# Access Compliance Report

## Public Rights-of-Way

### (Curb Ramps)

Intersection ID: 10040	Main Street: HAZEL_ST	Cross Street: TUCKASEEGEE_RD	Location: SE
ADA ID: 052A1EBF7BD3	Ramp Type: Directional1	Initial Pass/Fail: Fail	Overall Compliance: No
Severity Score: 8.75			
Codes/Mitigation Info/Possible Solution		Field Measurements/Component Compliance

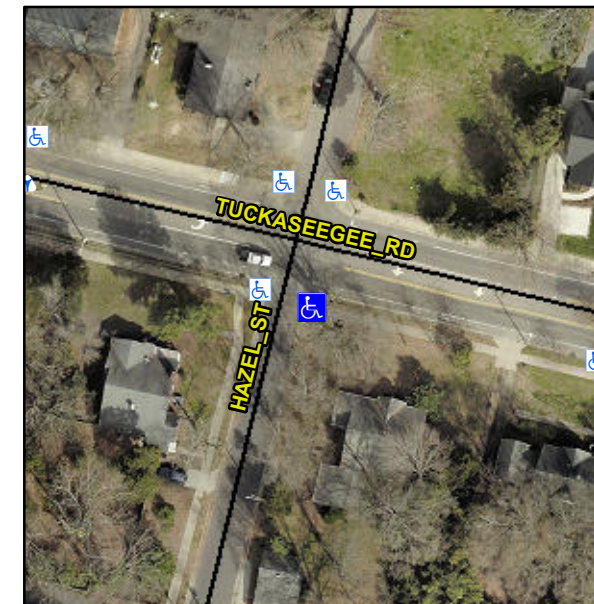
**R304.5.1**

**Remove & Replace Entire Ramp.**
